Estrella Substation and Paso Robles Area Reinforcement Project

Recirculated Portions of the Draft Environmental Impact Report

SCH #2018072071

November 2021

Figure 1-1.
Comparison of Estrella
Substation Fencelines,
Access Roads, and
Parcel Boundaries

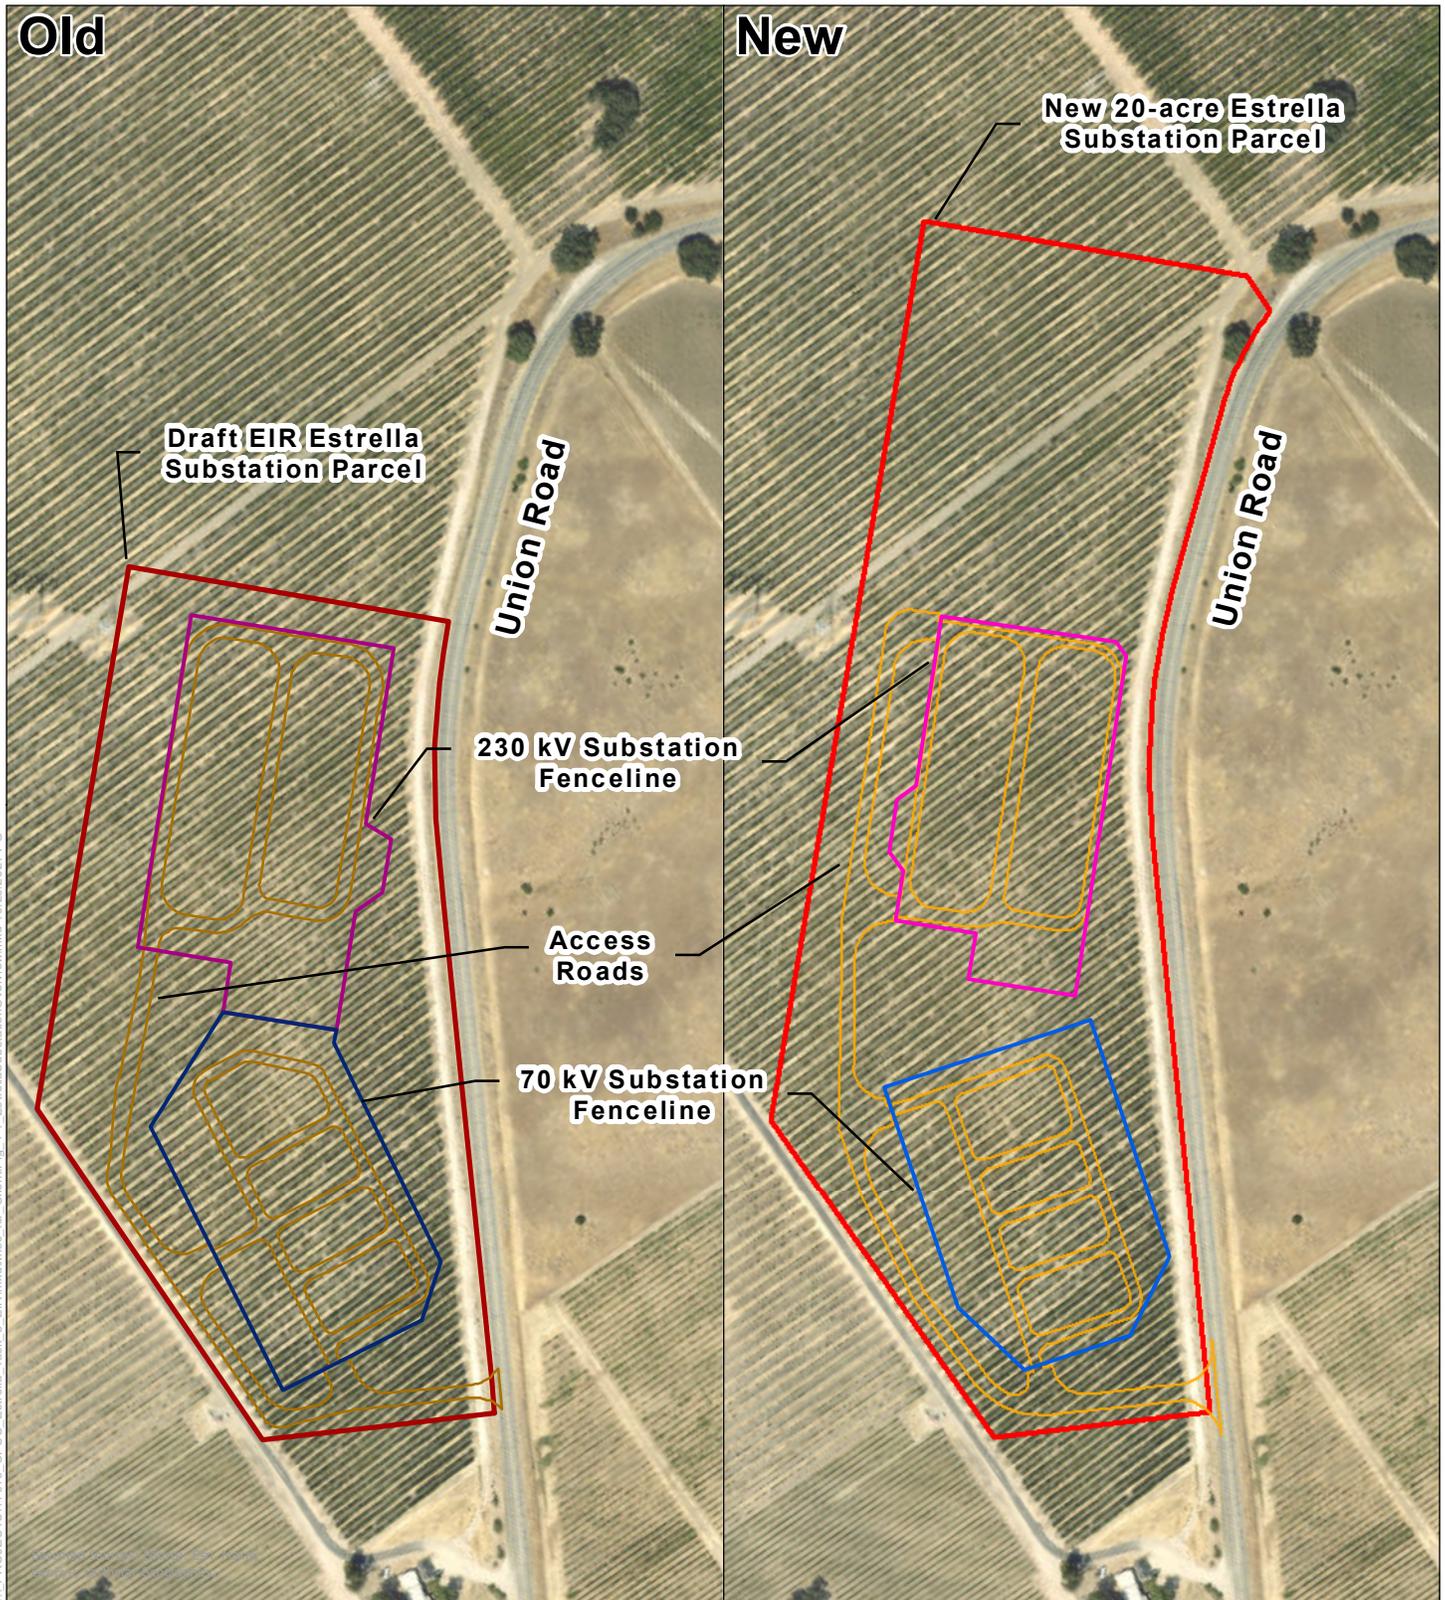
In reviewing the Proposed Project changes identified by HWT (see summary in Section 1.1.1), CPUC determined that one of these changes could substantially increase the severity of a significant impact identified in the DEIR. Specifically, the addition of the 5-acre area as part of the Estrella Substation parcel could substantially increase the severity of the Proposed Project’s effects on agricultural resources. Figure 1-1 shows a comparison of the Estrella Substation parcel boundary, as described in the DEIR, to the new substation parcel boundary identified in HWT’s comments on the DEIR.

As such, assuming that the additional 5-acre area acquired by HWT could be impacted (as stated in HWT's original comment letter), this would constitute a substantial increase in the severity of the significant and unavoidable impact to agricultural resources identified in the DEIR. Although HWT revised its comments to state that the additional 5 acres "will not be used during or following construction for any project activities" (HWT 2021b), it did not provide substantial evidence to ensure the agricultural resource will remain used for agricultural purposes. Given that the land would be owned by HWT, even if the land would not be used for utility purposes (at this time), it may be allowed to go fallow and/or may be managed in accordance with HWT's vegetation management guidelines. The continuance of farming on the parcel would be at the discretion of the former landowner (or possibly another entity) and incumbent on HWT to continue the farming agreement. Although HWT reports that an agreement has been reached with the landowner to continue farming this area, this agreement could be terminated or not renewed in the future.

Figure 2-7
 Estrella Substation and
 70 kV Power Line Components -
 Detailed View
 Sheet 1 of 8

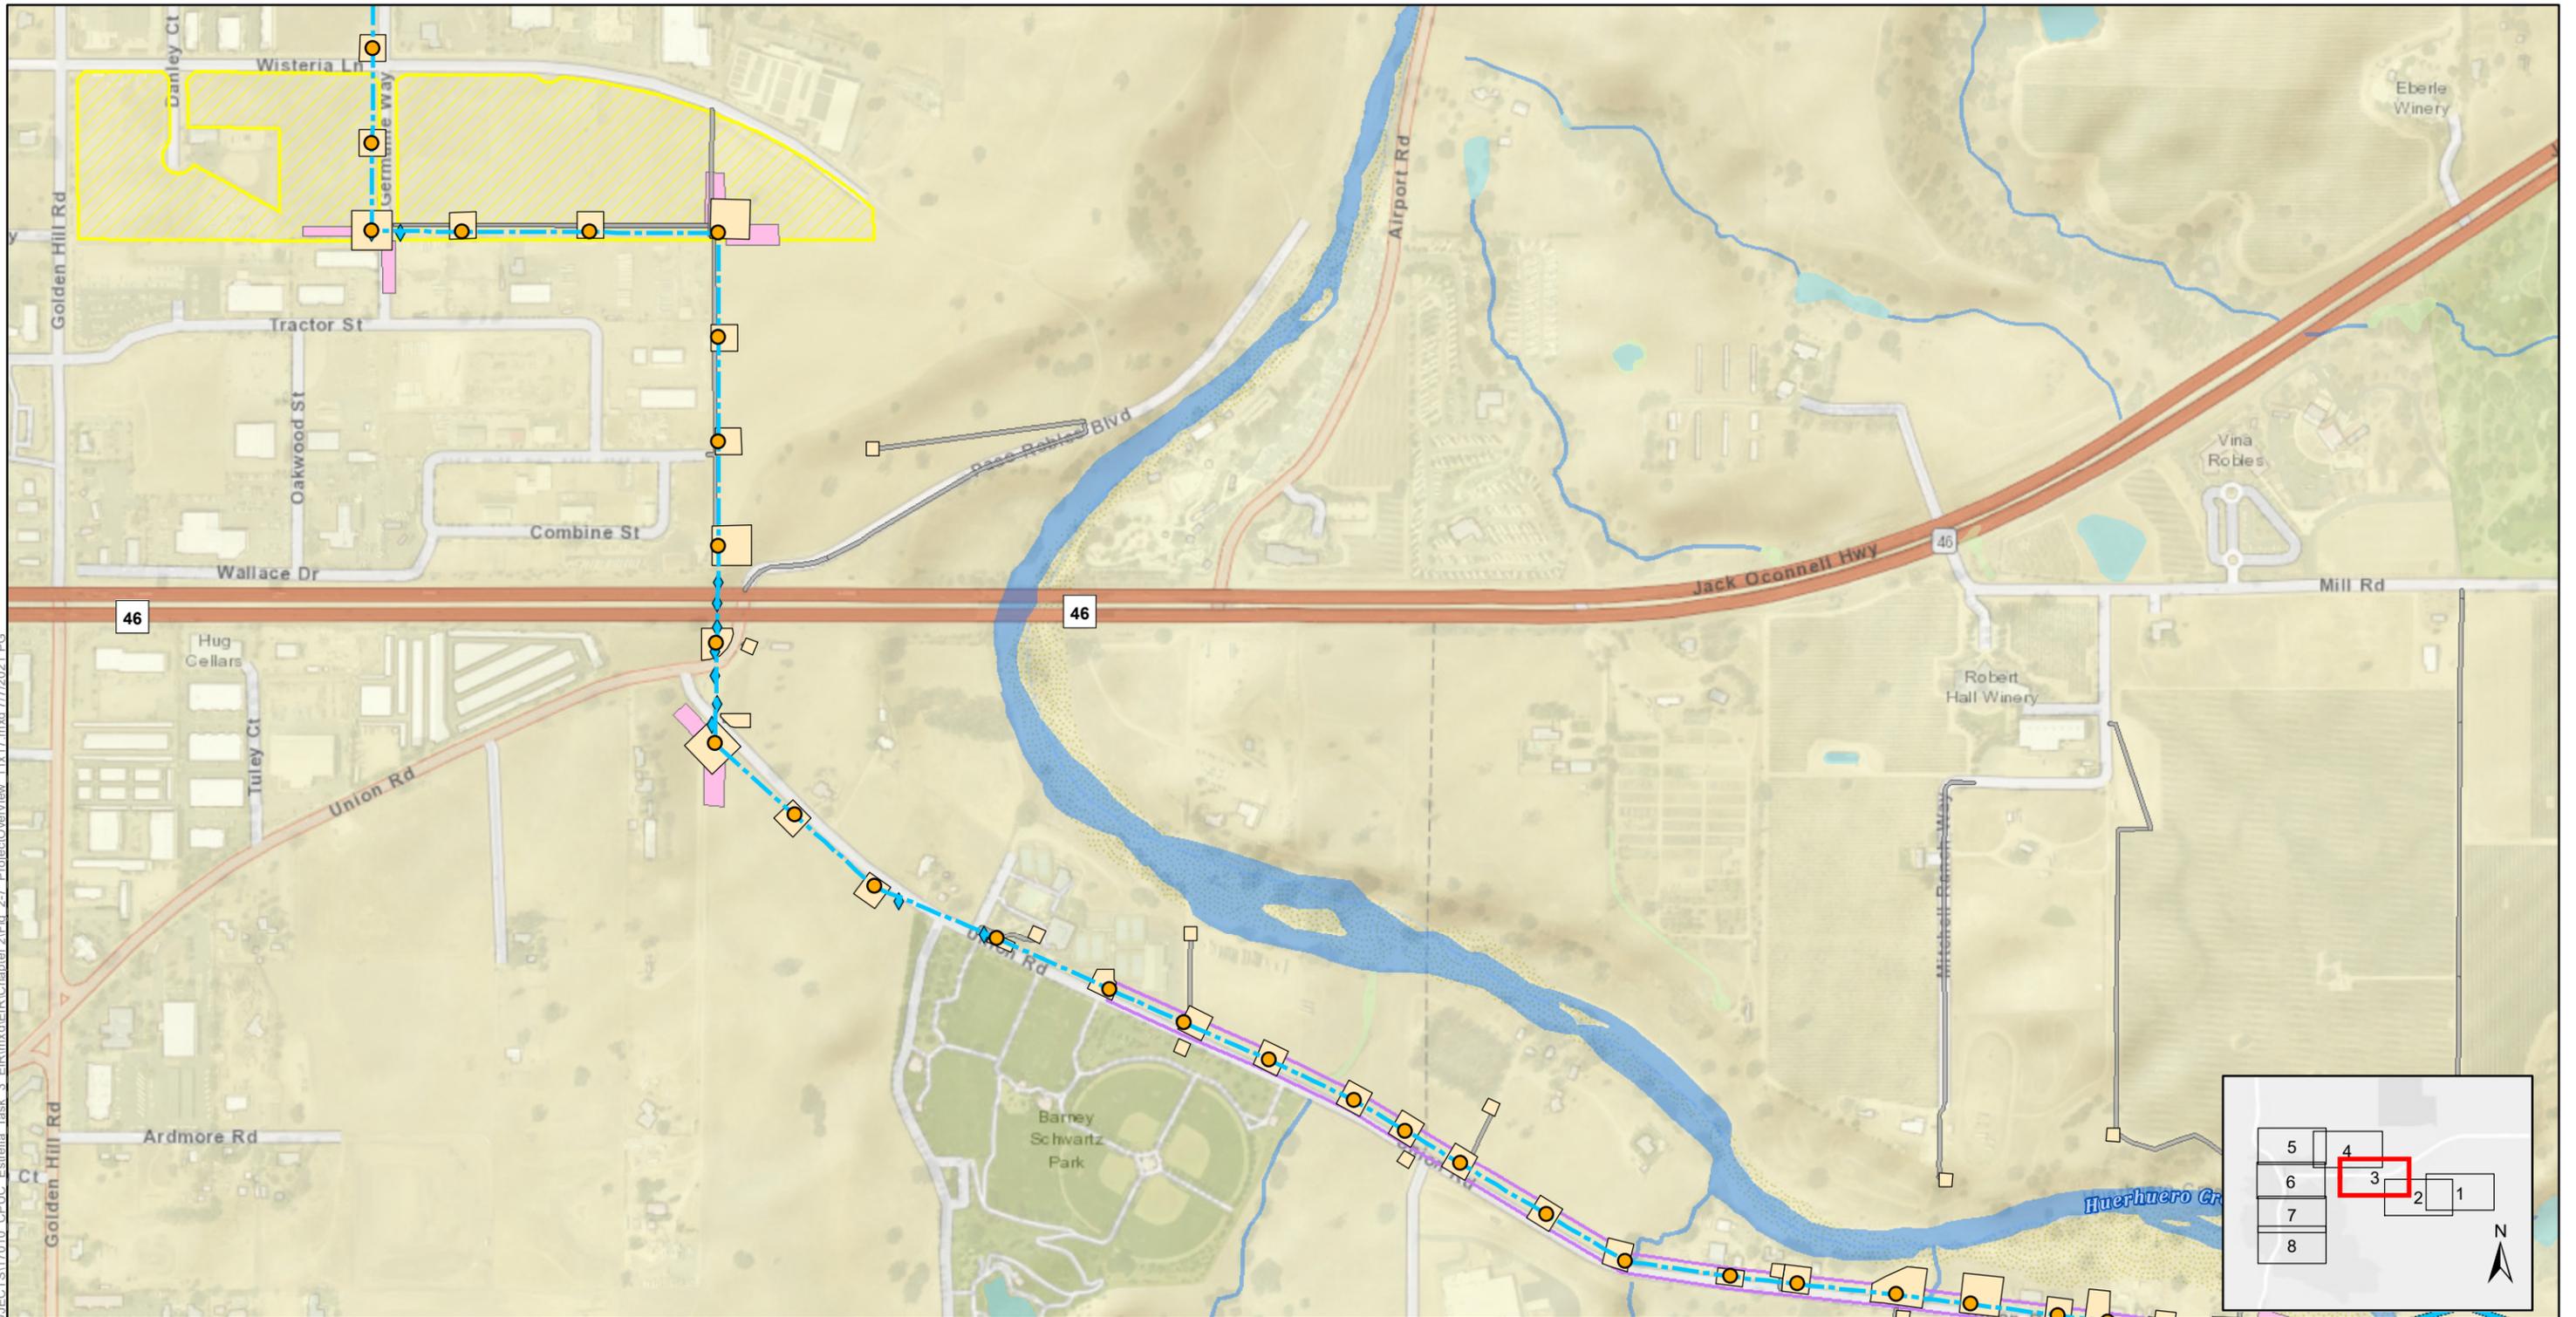
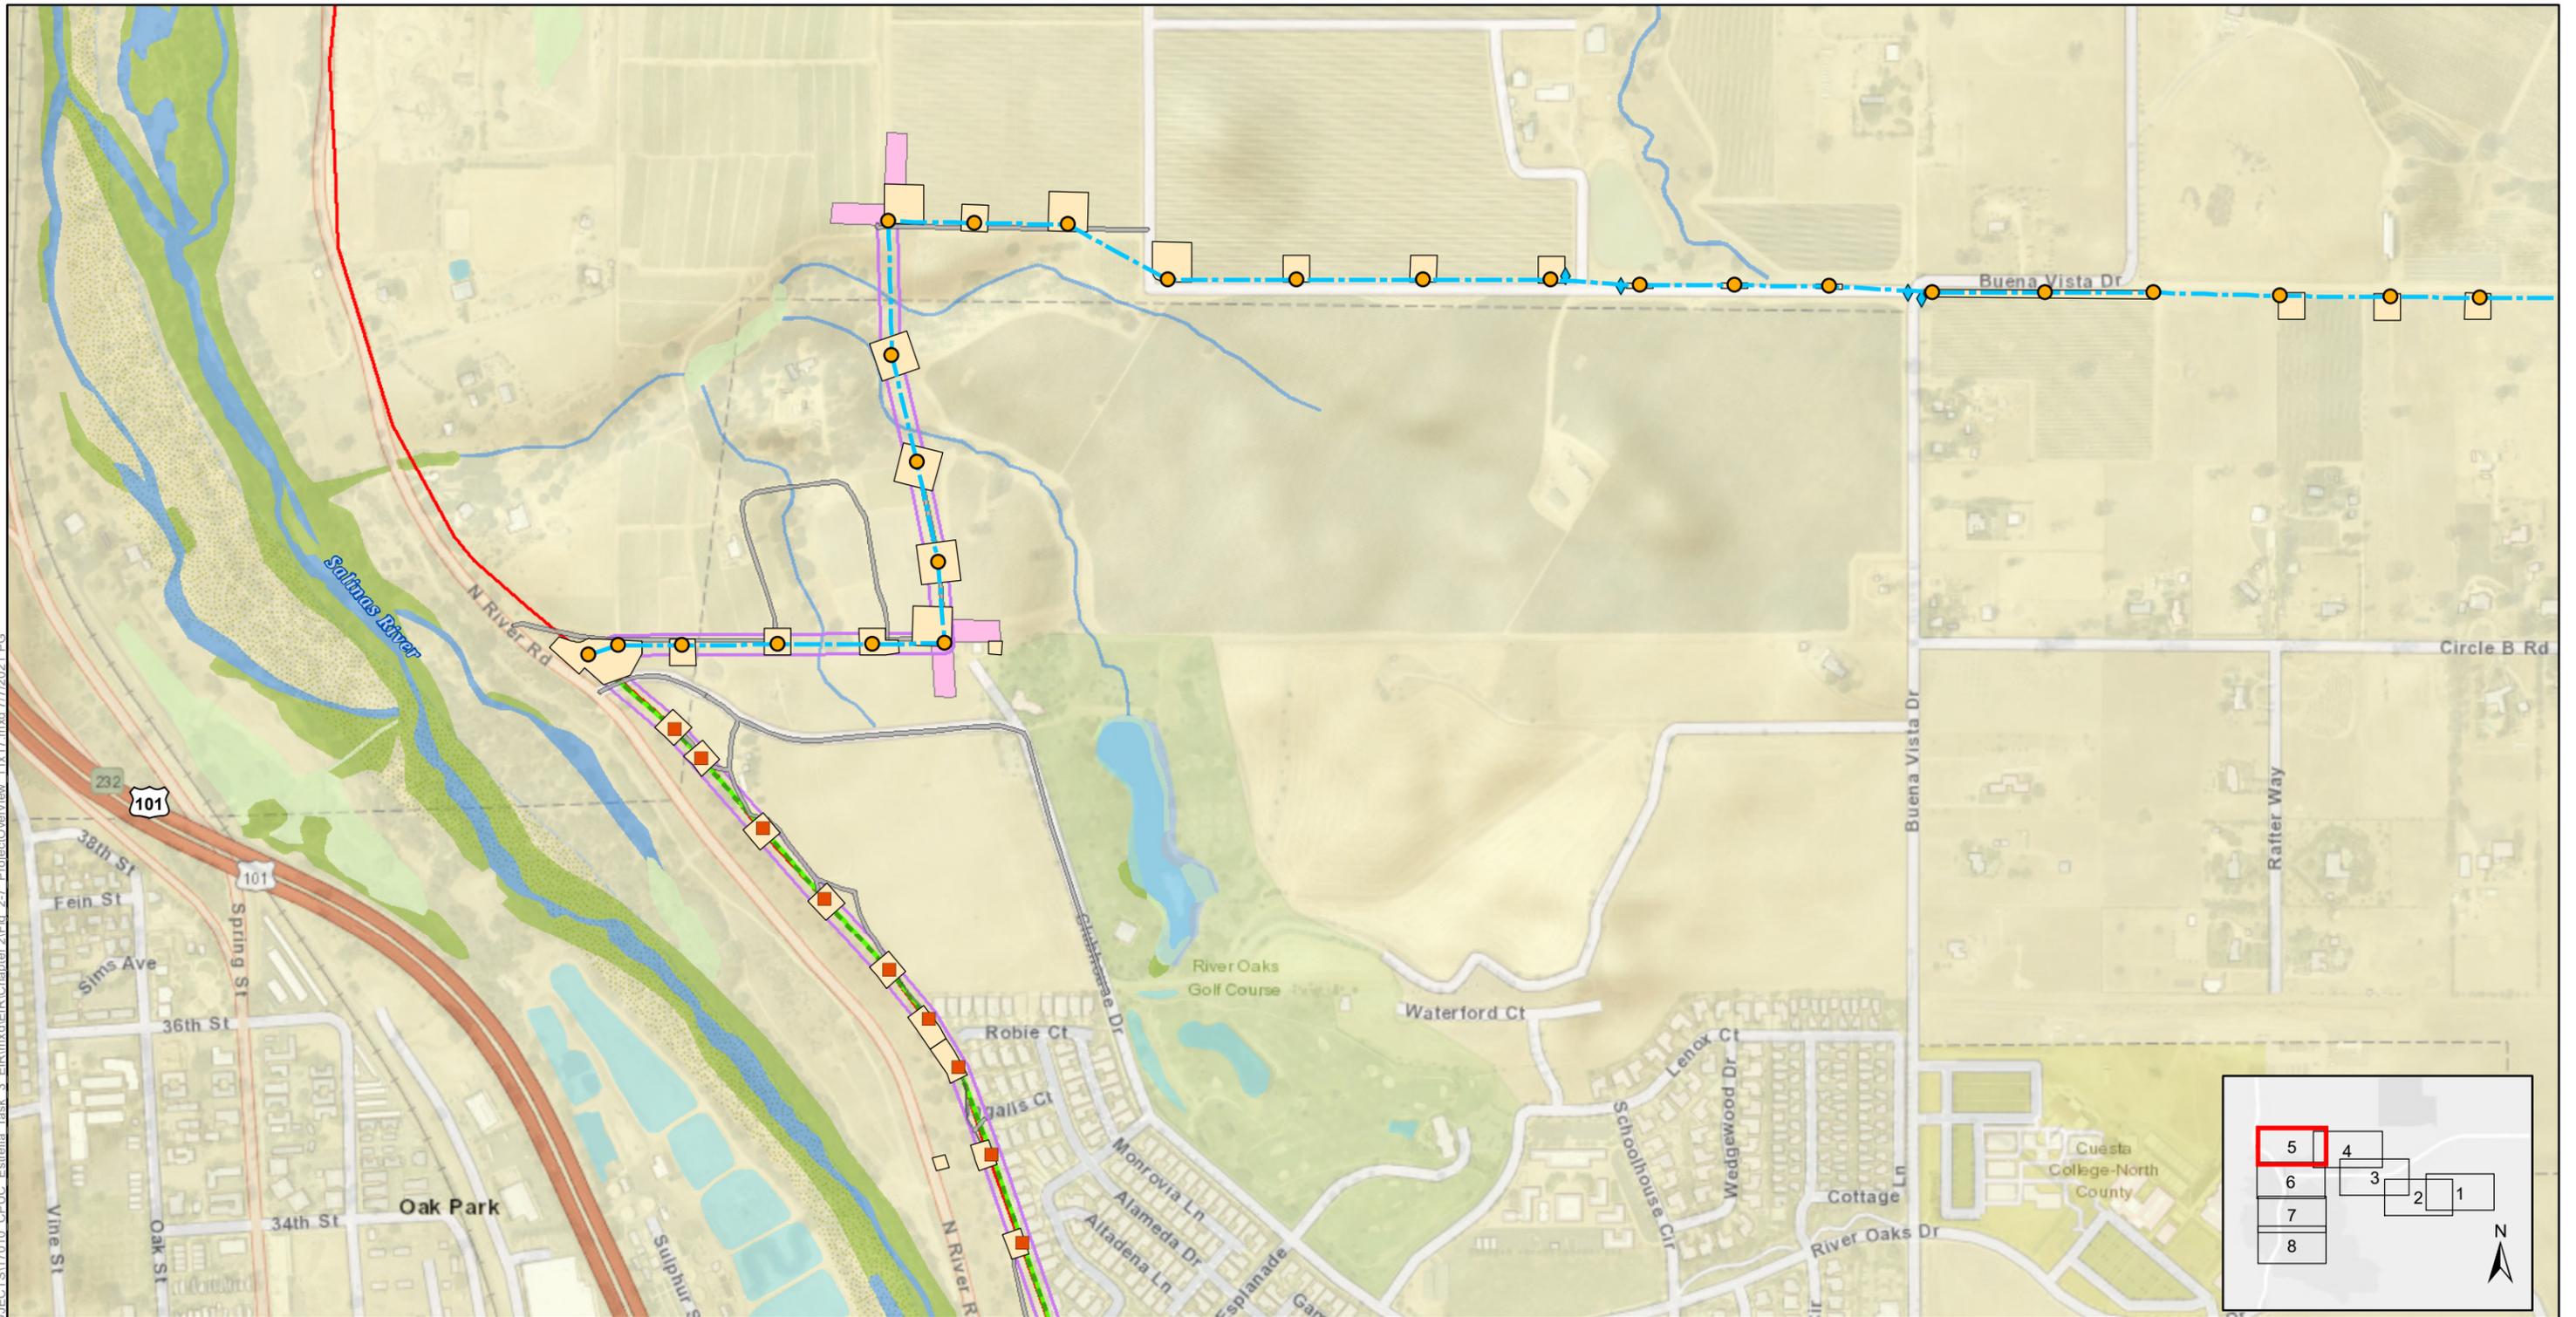
- **Estrella Substation Parcel Size.** The size of the Estrella Substation parcel is revised from 15 acres to 20 acres in several places in the text (Sections 2.2.1, 2.4). Figure 2-7 is also revised to show the larger substation parcel size.
